Appl. No. 10/771,800  
Amdt. dated 3 February 2006  
Reply to Office action of January 4, 2006

**Amendments to the Drawings:**

# ANNOTATED SHEET SHOWING CHANGES

Title: Trencher Unit, Docket 3120W

FIG. 2

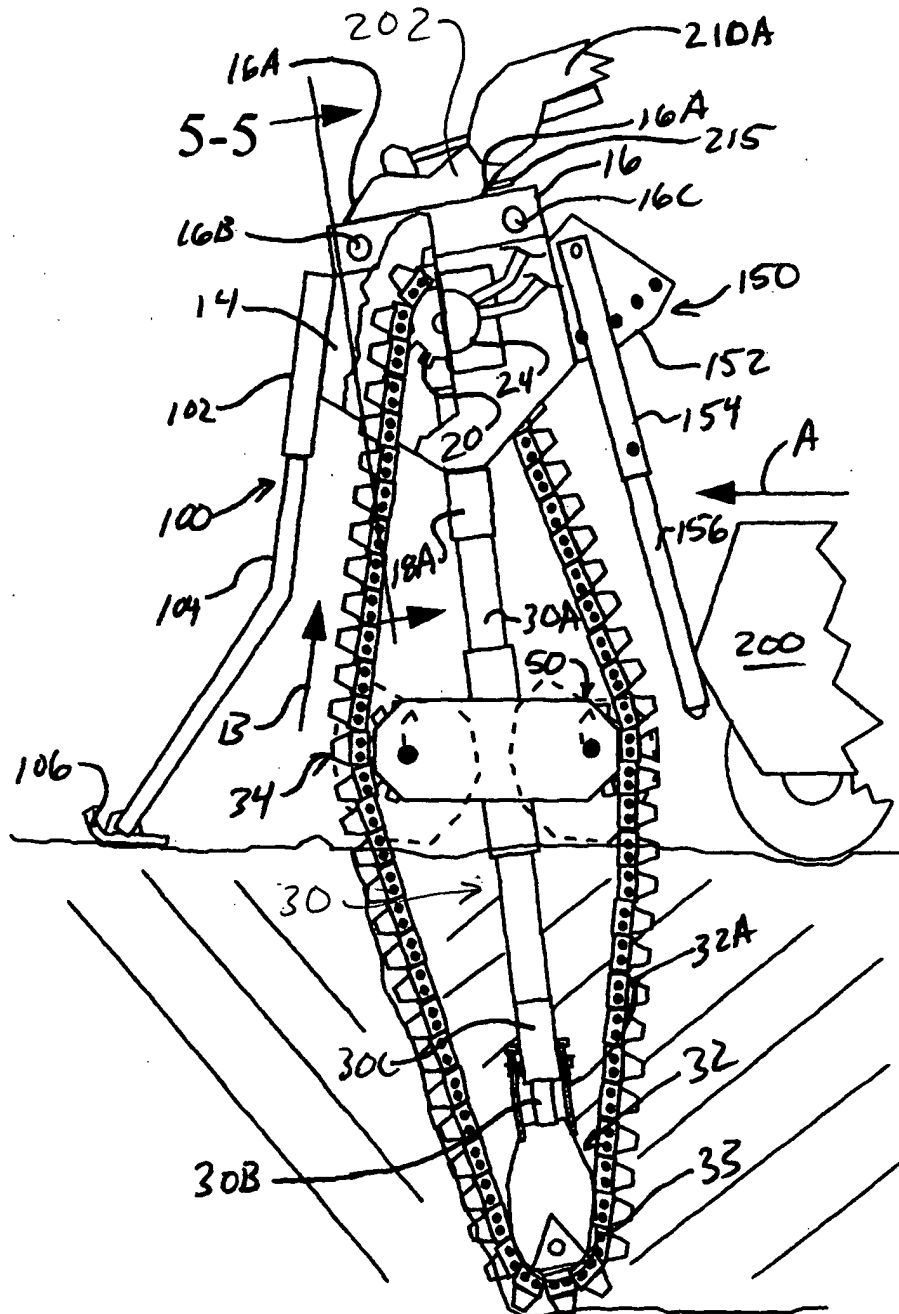
The attached sheets of drawings include changes to Figs. 2, 3, 3E, 3F, 5C, and 6A - 7C. These sheets, which include Figs. 2, 3, 3E, 3F, 5C, and 6A - 7C replace the original sheets including Figs. 2, 3, 3E, 3F, 5C, and 6A - 7C. In Fig. 2 previously omitted reference numerals 202 and 30 have been added. In Fig. 3 previously omitted reference numeral 30 has been added. In Fig. 3E previously omitted reference numeral 50 has been added. In Fig. 5C previously omitted reference numeral 14 has been added. In Figs. 6A, 6B, 7A, 7B and 7C previously omitted reference numerals 30 and 34 have been added. In Fig. 6C previously omitted reference numerals 30, 34 and 50 have been added.
